Intel® Pentium® III Processor Specification Update

Release Date: December 2001

Order Number: 244453-036

Pentium® III Processor with 512KB L2 Cache Platforms Workaround

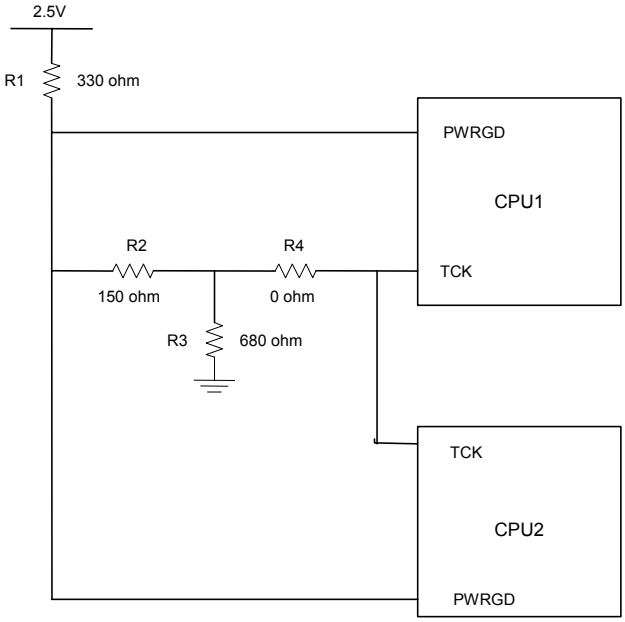
Workaround: To prevent the risk of power-on boot failures or catastrophic thermal failures, a platform workaround is required. The system must provide a rising edge on the TCK signal during the power-on sequence that meets all of the following requirements:

Assumes the inputs to the CPU_PWRGD are open collector signals that are Wire-ANDed together

- The example workaround circuit assumes that the PWRGD inputs into the processors are open collector. Tying the PWRGD inputs together in a Wired-AND fashion allows each processor to receive PWRGD at the same time but at the latter of the 2 separate PWRGD assertions. If separation of the PWRGD inputs to each processor is required, extra circuitry will be required.
